**Subject: PALEN SOLAR HOLDINGS, LLC'S RESPONSE TO WORKSHOP  
QUERIES  
PALEN SOLAR ELECTRIC GENERATING SYSTEM  
DOCKET NO. (09-AFC-7C)**

# **Response to Workshop Queries**

## **PALEN SOLAR ELECTRIC GENERATING SYSTEM**

(09-AFC-7C)

**FIGURE DR 5-3 TO PSH'S DATA RESPONSES SET 1**

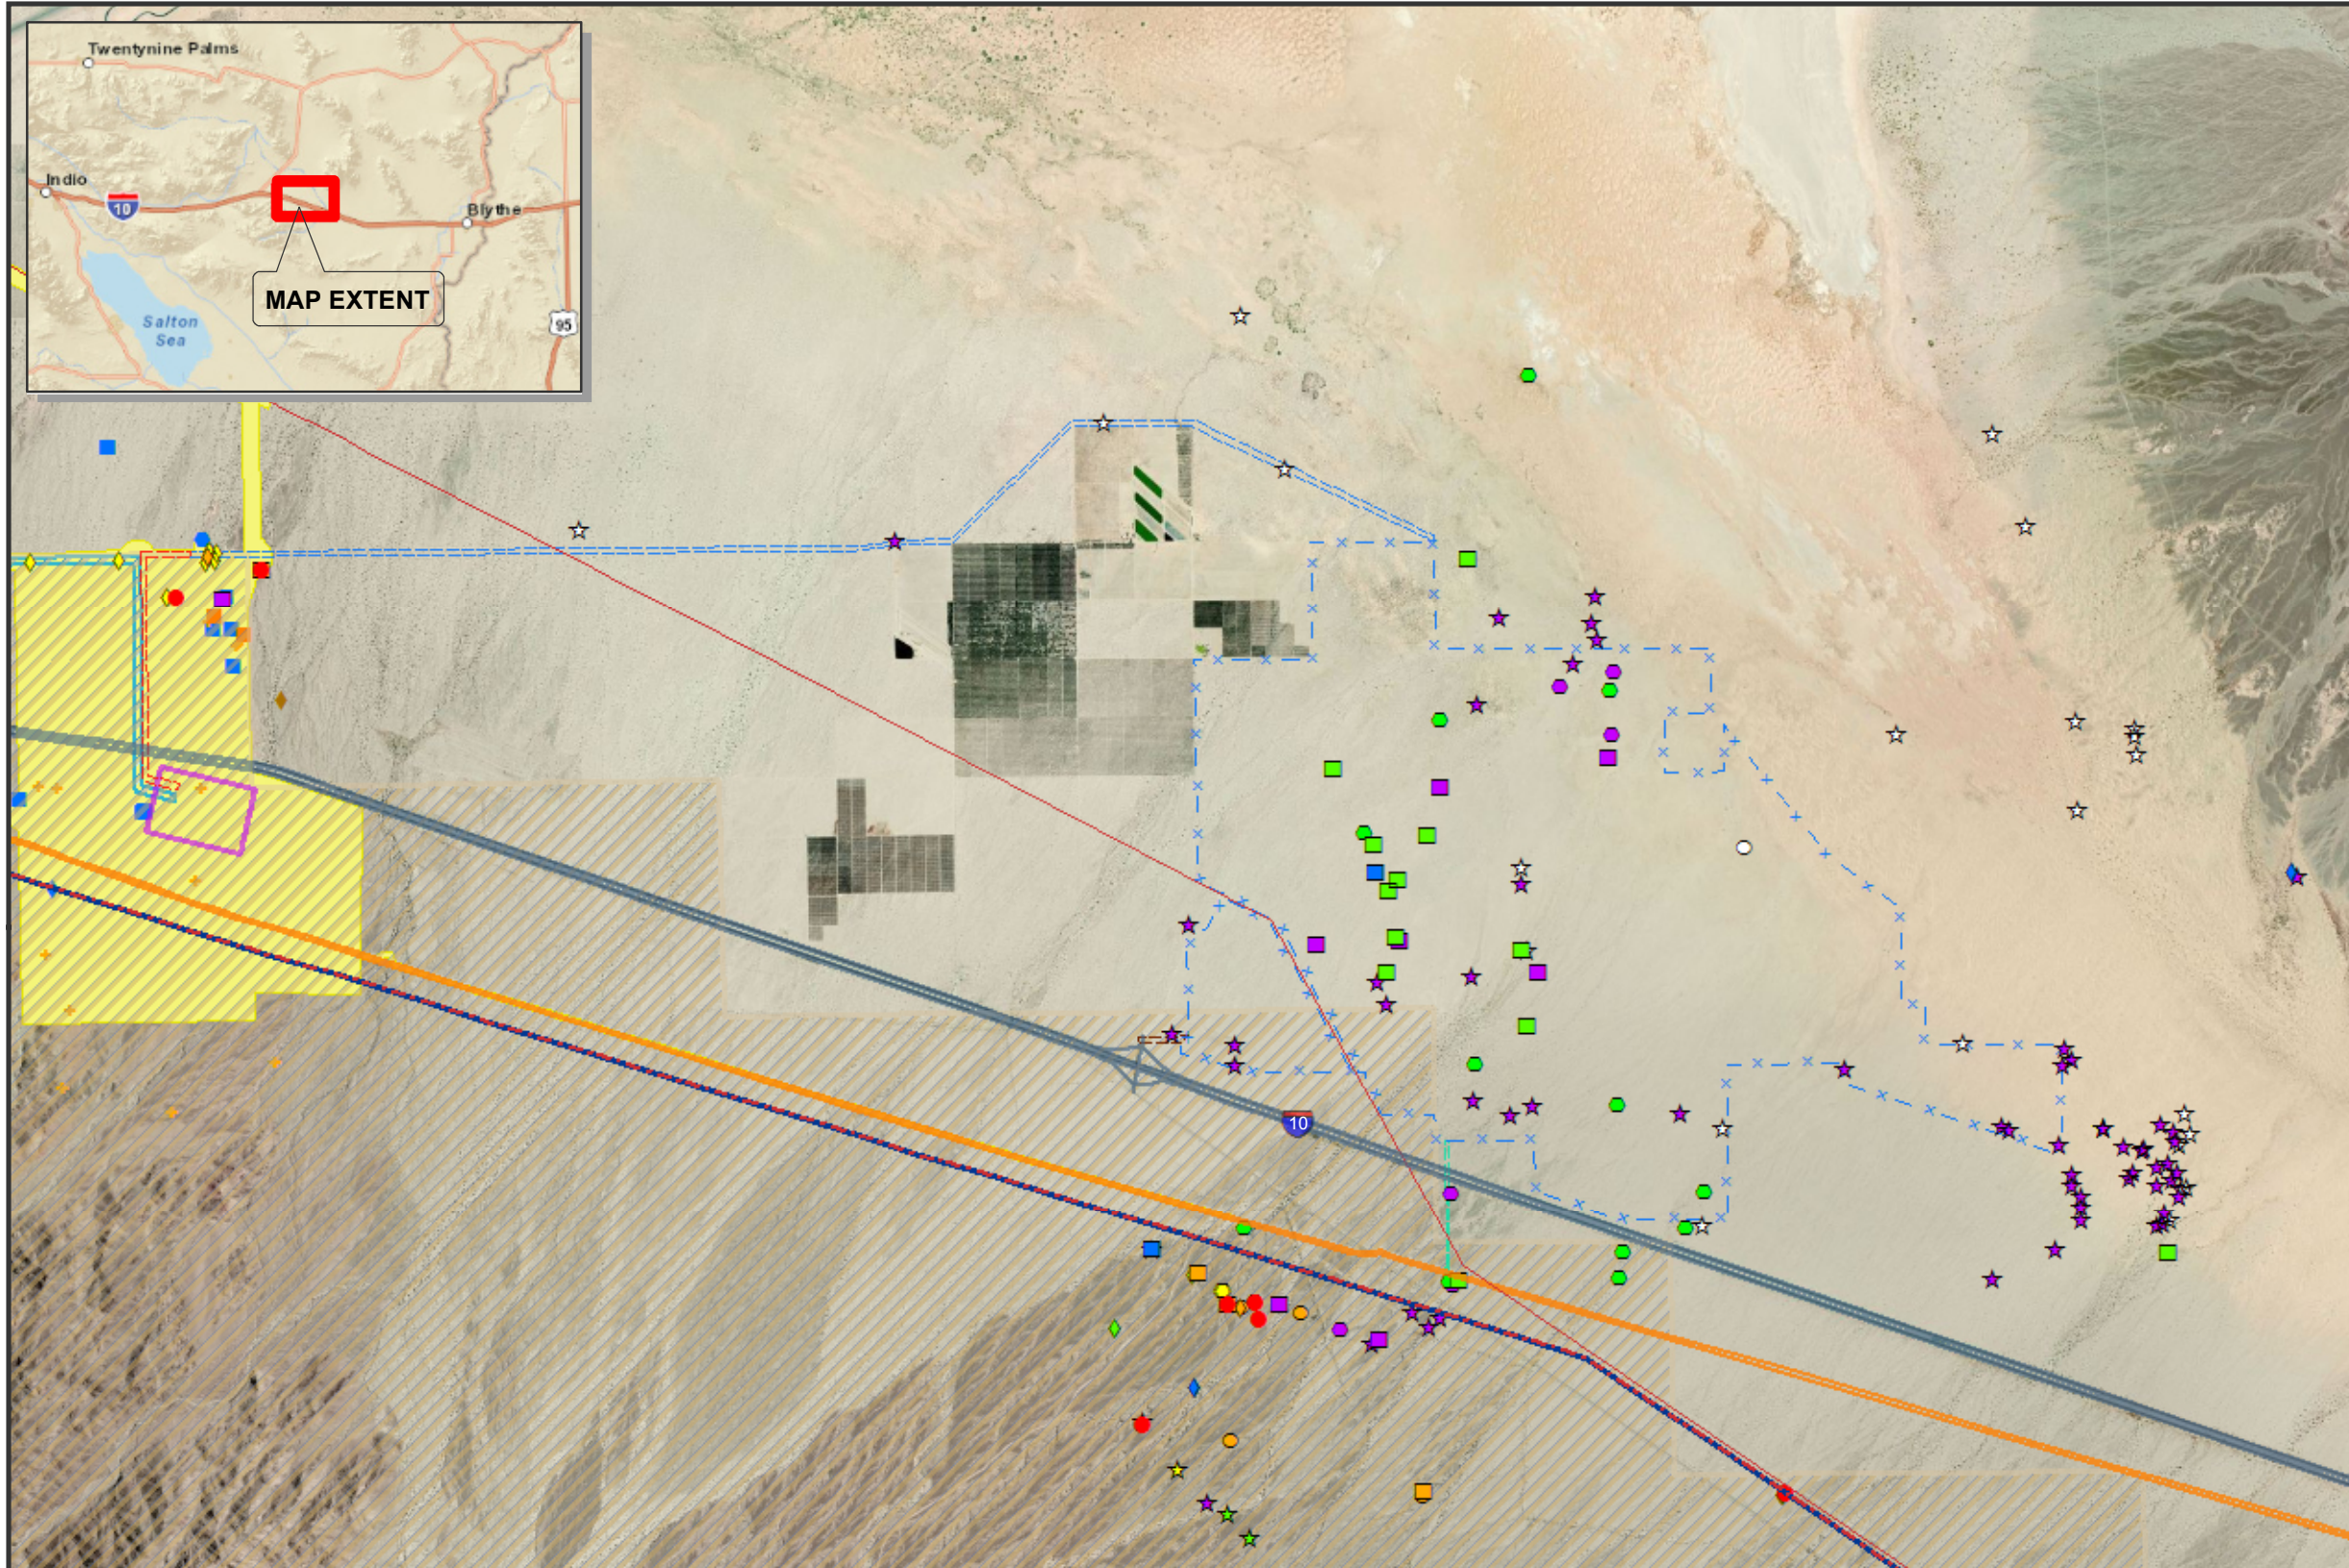
**WSQ 1-6     *How close is the PSEGS gen-tie line to the Desert Sunlight survey area?***

The westerly shift of the PSEGS generation tie line was elected for the purpose of locating the line adjacent to the permitted Desert Sunlight generation tie line. The westerly shift is entirely within the Desert Sunlight Survey Area as shown in Figure DR 5-3 to PSH's Data Responses Set 1. See Attachment WSQ 1-6-1.
